# VALUE ENGINEERING REPORT

SR 284 over the Chattahoochee River/Lake Lanier  
BRST-2424(3), P.I. No. 142291  
Hall County

April 29, 2009

VALUE ENGINEERING STUDY  
BRST-2424(3), P.I. No. 142291  
SR 284 over the Chattahoochee River/Lake Lanier  
March 30 – April 2, 2009

Idea No.: A-16  
Client: GADOT  
Sheet 2 of 4

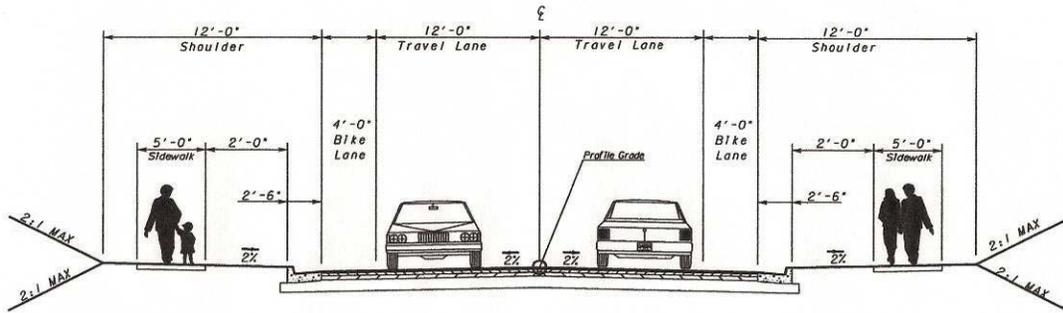
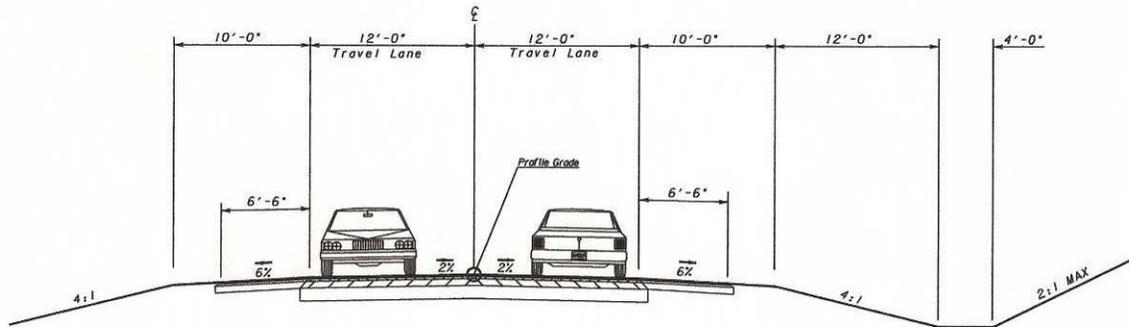
The current roadway design calls for two 12-foot travel lanes, two 4-foot bike lanes, and a 12-foot wide urban shoulder with curb and gutter and sidewalks on both sides of the road. The current bridge design calls for an urban section with two 12-foot lanes, two 4-foot bike lanes, and curb and gutter with 6-foot sidewalks on both sides.

**Proposed Change:** It is recommended that a rural roadway/bridge typical section be used for the entire length of the project. The rural roadway section would consist of two 12-foot travel lanes and two 10-foot shoulder (6.5-feet paved). The rural bridge section would consist of two 12-foot travel lanes and two 10-foot shoulders.

**Justification:** The existing SR 284 roadway section consists of a rural 2-lane facility with no sidewalks on either end. The existing bridge section consists of a 28-foot wide structure with no sidewalks. The project does not appear to be in an area that would generate pedestrian traffic along the roadway. Individuals would most likely drive and park in the County Park on the north side of the project and simply cross SR 284 to attend rowing events, thus negating the need for sidewalks on the project.

The bicycle lanes could easily be accommodated on the roadway and bridge paved shoulders (there are no bike lanes on the existing facility). This concept would reduce the width of the typical section, the embankment, some full depth asphalt pavement, and project R/W needs. Using a rural shoulder instead of the proposed urban shoulder plus bicycle lanes and sidewalks could reduce the bridge width by approximately 4 feet.

<b>IDEA No.:</b> J-1	<b>Sheet No.:</b> 1 of 5	<b>CREATIVE IDEA: <u>Option 1</u></b> Relocate the pedestrian culvert underpass and new dual park entrances closer to the existing park driveway entrances.
-------------------------	-----------------------------	---

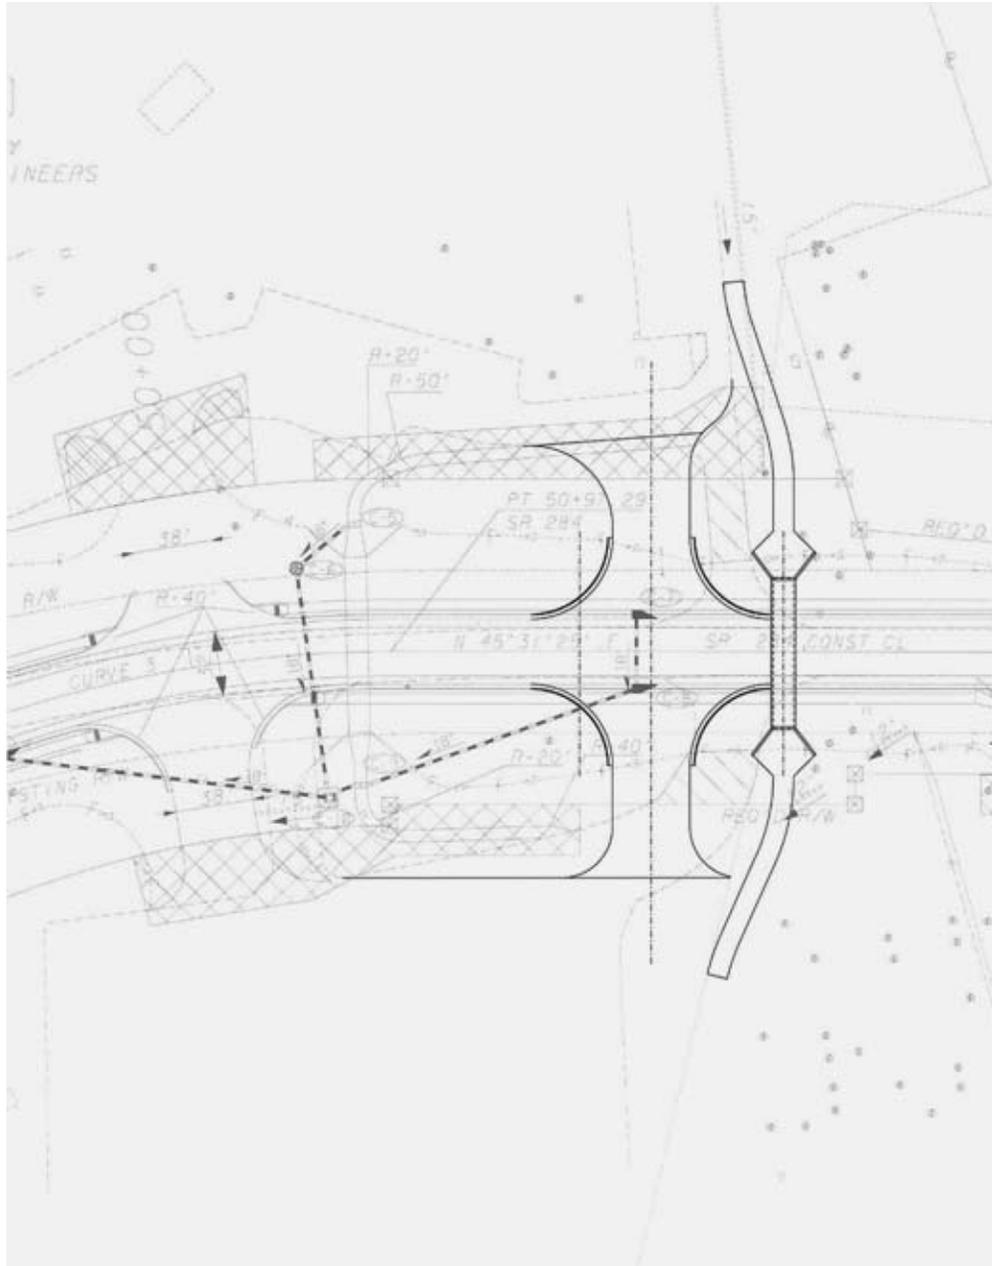
**Original Concept:** The original design moves the current park entrance driveways approximately 270 feet south of their current intersection with SR 284. Shifting the park driveways south allows room for a new 10-foot x 8-foot pedestrian culvert underpass to be constructed just north of this revised driveway intersection.

It is recommended that the new park entrance driveways be relocated back to their existing location (Station 52+20) and the pedestrian underpass culvert be constructed just north of the new entrance driveways (Station 52+90) and that the pedestrian underpass approach sidewalks be widened to 10 feet to easily accommodate wheelchair pedestrians traveling in opposite directions.

**Justification:** Shifting the park entrance driveways back to Station 52+20 will remove the intersection from the horizontal curve on SR 284. This shift will provide better sight distance, eliminate the SR 284 superelevation from the intersection, and may reduce the steep grades on the two driveways.

Shifting the pedestrian culvert underpass to Station 52+90 will place the underpass directly in the primary pedestrian flow path from the rowing venue’s buildings/marina on the west side of SR 284 and the rowing course viewing/competition area on the east side of SR 284. Constructing the underpass at this location would shorten the culvert, its connecting sidewalks, and eliminate the 90 degree turns in the currently designed approach sidewalks. Constructing the underpass at this location would allow it to be raised reducing underpass drainage impacts and allowing for a reduced grade on the approach sidewalks.
